**BEFORE THE OIL CONSERVATION DIVISION
EXAMINER HEARING JULY 23, 2024**

CASE NOS. 24279 & 24280

ANGEL RANCH SWD

**APPLICATIONS OF RILEY PERMIAN OPERATING COMPANY, LLC,
FOR APPROVAL OF A SALT WATER DISPOSAL WELL,
EDDY COUNTY, NEW MEXICO.**

Exhibit A-2

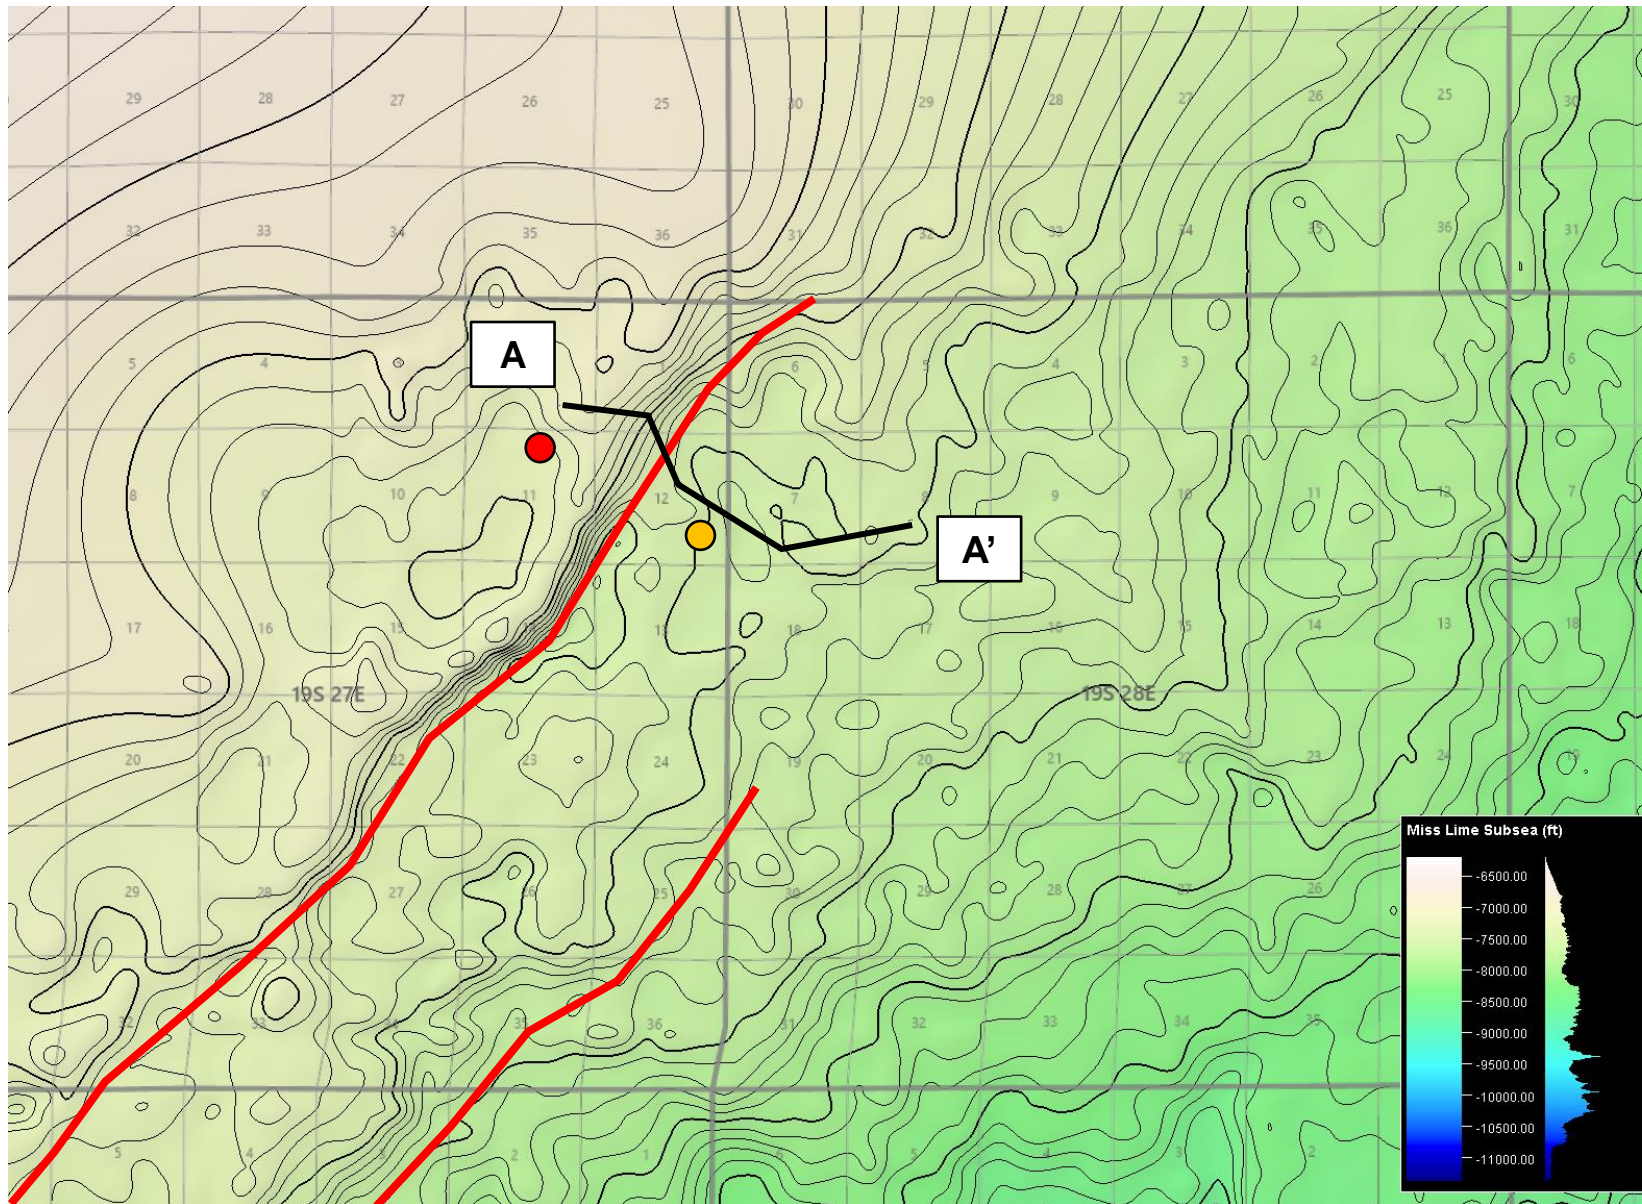
7. **Matador Exhibit A-2** contains a subsea structure map that I prepared off the top of the Mississippi Lime formation. The contour intervals are 50 feet. I have also identified the locations of Riley's proposed Angel Ranch SWD #1 and Angel Ranch SWD #2 SWD with red and orange circles, respectively. The structure map shows the presence of a significant fault in this area, which I have shown using a red line on Exhibit A-2. As reflected on Exhibit A-2, this fault runs close to both of Riley's proposed SWD locations.

12. My concerns are further compounded by the presence of the fault identified in MRC Exhibit A-2 and A-3. Due to the fault, the vertical separation between Riley's proposed injection interval and Matador's Third Bone Spring target could be much closer than 400 feet in parts of this area. In addition, the fault could allow for easier flow of water from the injection interval into the Third Bone Spring target, causing the negative impacts described above.

Exhibit A-3

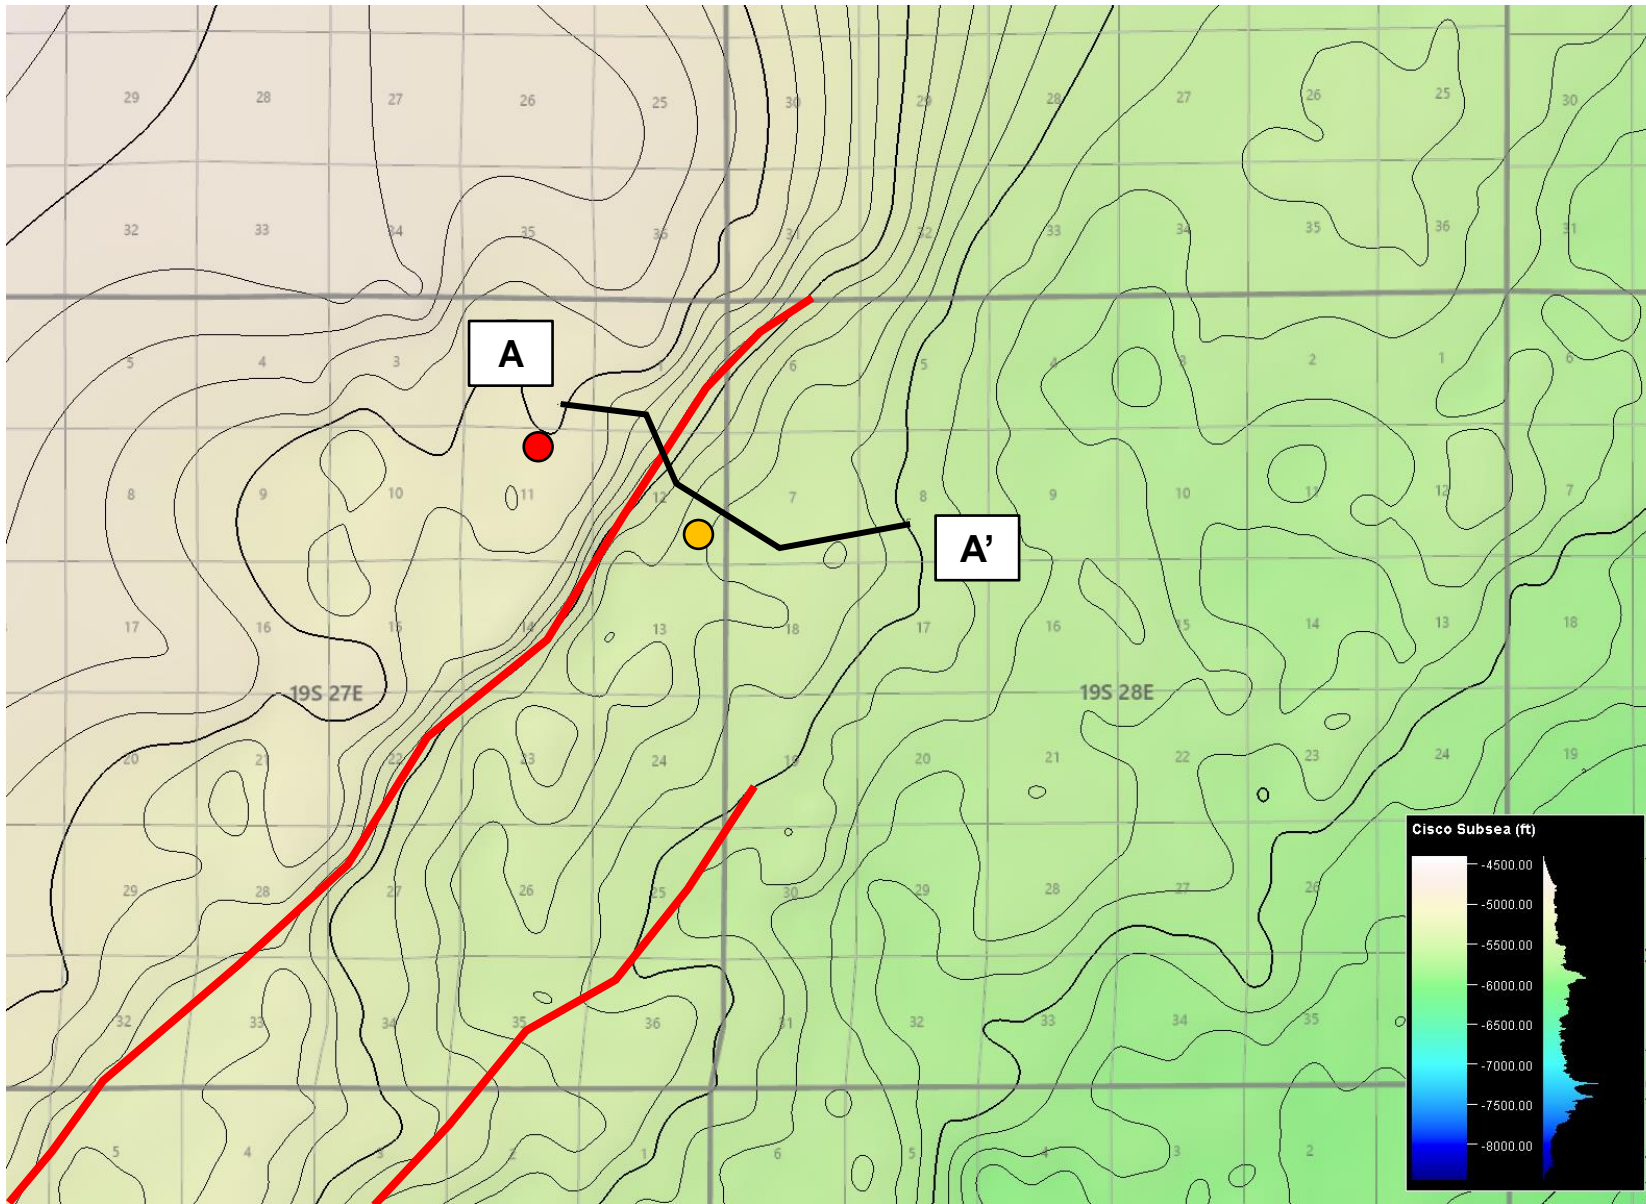
8. **Matador Exhibit A-3** contains a subsea structure map that I prepared off the top of the Cisco formation. The contour intervals are 50 feet. I have also identified the locations of Riley's proposed Angel Ranch SWD #1 and Angel Ranch SWD #2 SWD with red and orange circles, respectively. Although the fault identified in Exhibit A-2 is basement-rooted and offsets deeper stratigraphy, this structure map confirms the fault-propagated folding of the overlying

Cisco formation, which is the proposed injection interval for both of Riley's proposed SWDs. Fracturing associated with this fault-propagated folding through the Cisco and early Permian strata increases the risk of vertical communication between the water injection interval and the Third Bone Spring reservoir.

Exhibit A-4

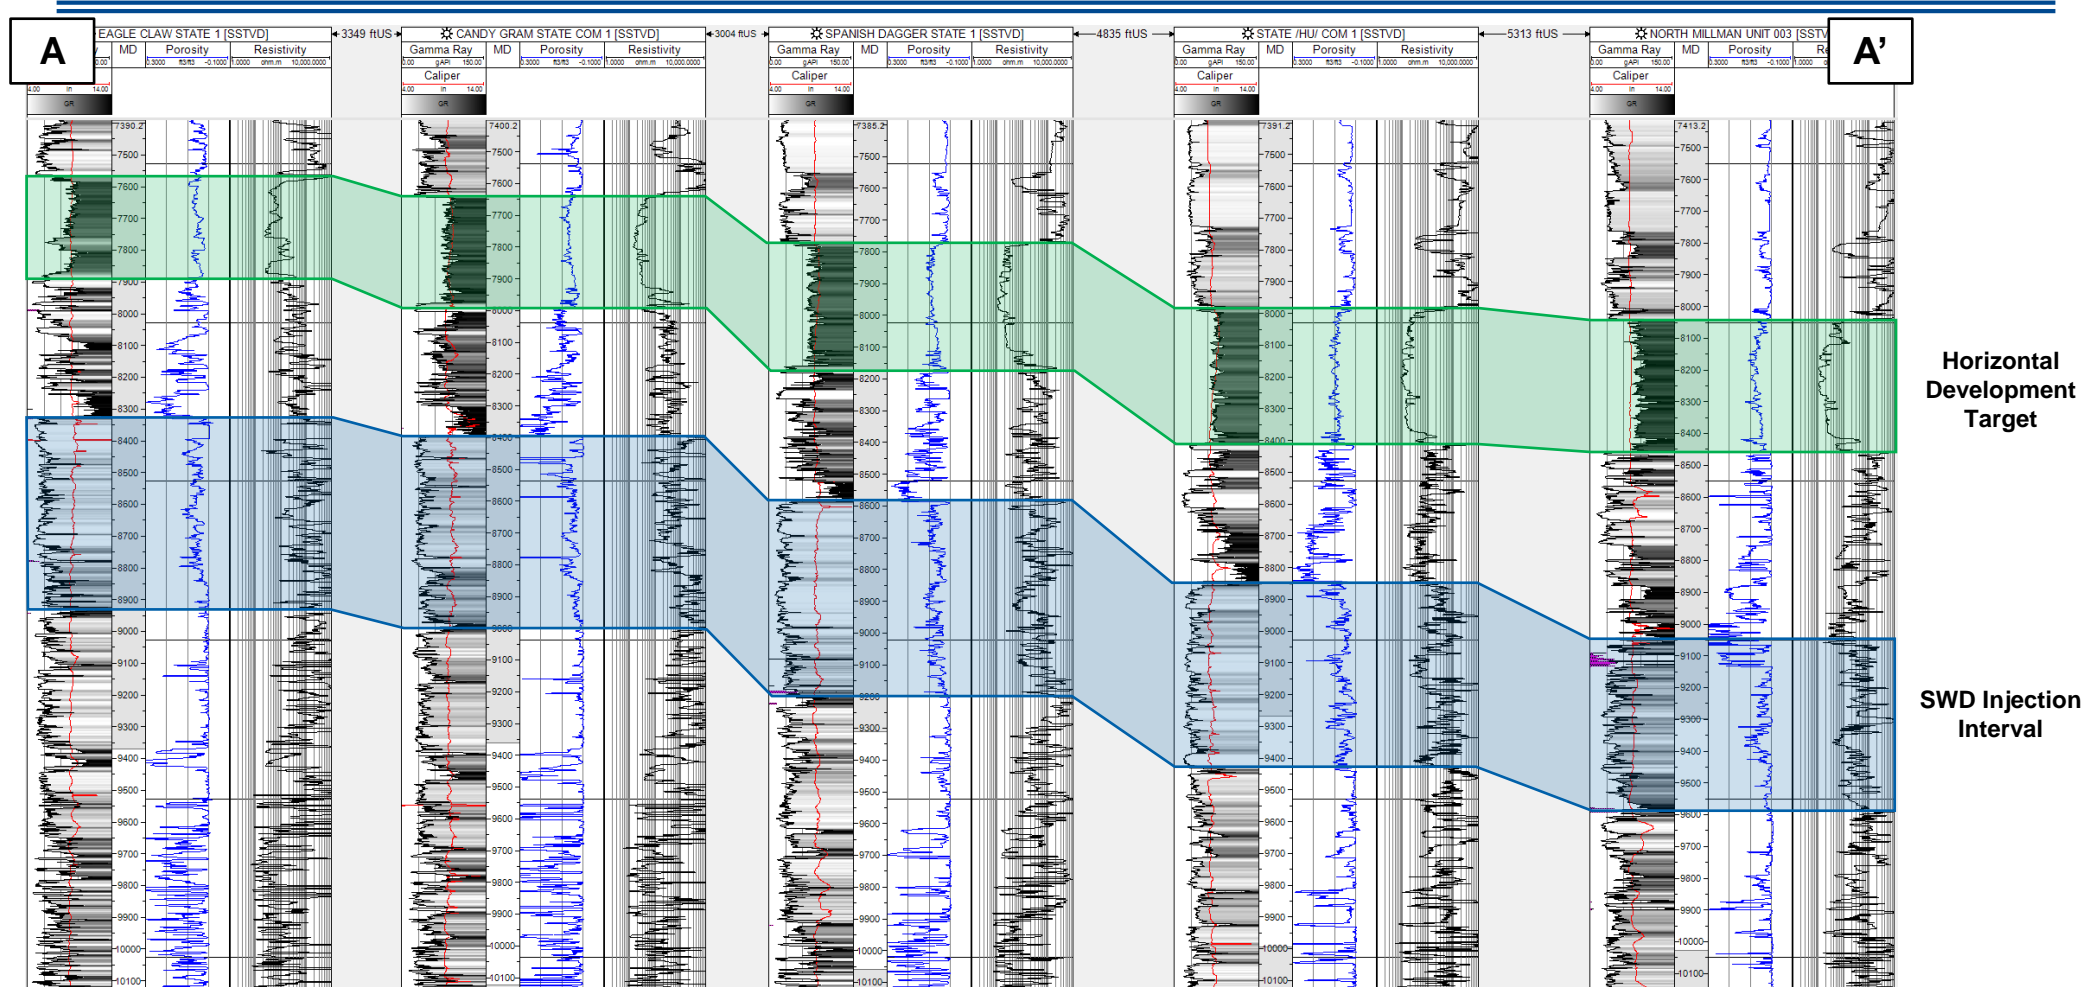
9. **Matador Exhibit A-4** is a structural cross-section that I prepared displaying open-hole logs run from the five representative wells denoted from A to A' on Exhibit A-2 and Exhibit A-3. The wells in the cross-section contain gamma ray, resistivity, and porosity logs. Highlighted in green is the Third Bone Spring target that Matador intends to be developed on its adjacent acreage in this area. Highlighted in blue is the injection interval that Riley has proposed for its two proposed SWD locations.

10. As shown on Exhibit A-4, there is only approximately 400 feet of vertical separation between Riley's proposed SWD injection interval and Matador's Third Bone Spring target it intends to develop using horizontal wells. I do not identify any clear geologic barriers between the proposed injection interval and Matador's horizontal target that would prevent vertical migration of the produced water Riley proposes to inject into its SWDs into the shallower Third Bone Spring.

Exhibit A-5

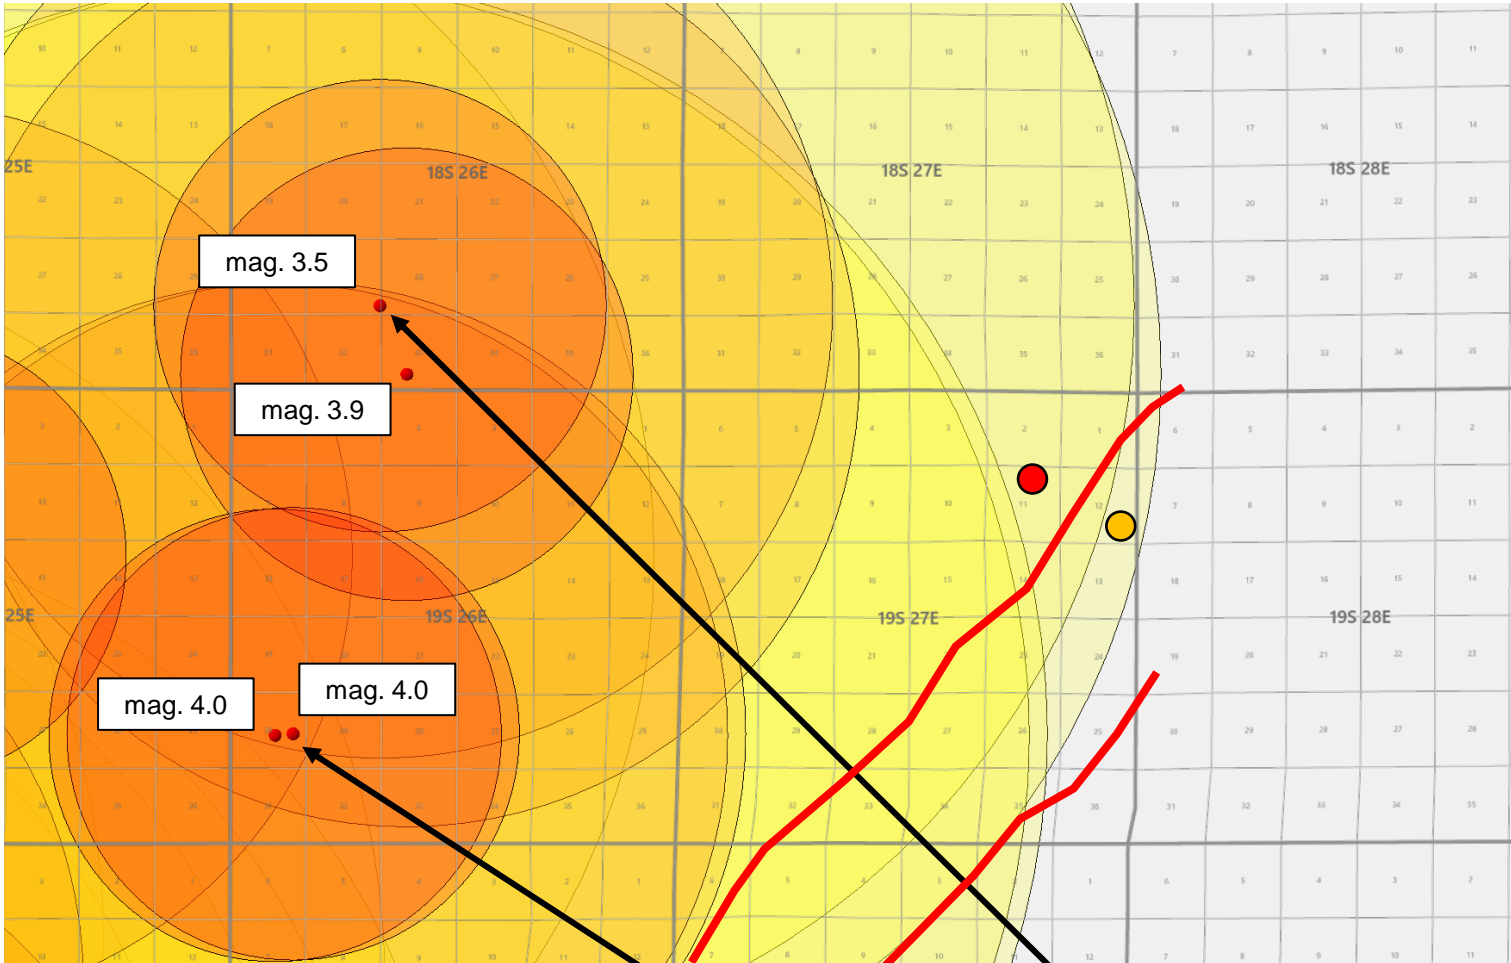
13. **Matador Exhibit A-5** shows recent seismic activity of magnitudes greater than 3.5 to the west of the proposed Angel Ranch SWD wells. The seismic response radii are highlighted in red (3-mile radius), orange (6-mile radius), and yellow (10-mile radius). The Angel Ranch SWD wells both fall within a 10-mile radius of recent activity. At the bottom of Exhibit A-5, moment tensor data from 2 recent events demonstrates that the orientation of failure is roughly southwest to northeast, which is also sub-parallel to the fault orientation mapped in the Angel Ranch SWD area. This demonstrates that the mapped fault orientation is prone to failure in the modern stress environment.
